# Intel® Technical Advisory

TA-901-1

## Hard disks may not initialize if only two disks are installed in the Intel® Entry Storage System SS4200-E

Intel® Entry Storage System SS4200-E

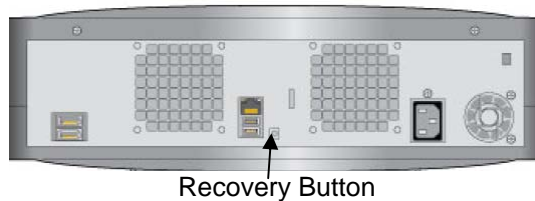
When installing only two hard disk drives in the Intel® Entry Storage System 4200-E, the drives may be identified in "parity" mode instead of "mirror" and will not initialize. A message in the GUI will state "Data on your storage device is currently unavailable". The power button LED will illuminate, and stay, amber.

Some systems may have been set for a four drive configuration during factory test.

Install four drives into the storage system or proceed with the workaround.  
This issue will be fixed in a future software release.

1. Install two drives into drive retention brackets numbered 1 and 2 as described in the user guide.
2. Connect power cable to storage system.
3. Press and hold the Recovery Button, located on the back of the system, while powering on the storage system (press, then release the power button on the front panel).

4. After a short delay, the front panel power indicator LED and drive LEDs will flash three or four times in unison then stop.
5. After the LEDs have stopped flashing, release the reset button and allow the system to reboot. This process may take longer than normal due to the reset process of the system software.
6. Follow the instruction to load the client storage system software and configure the storage system.
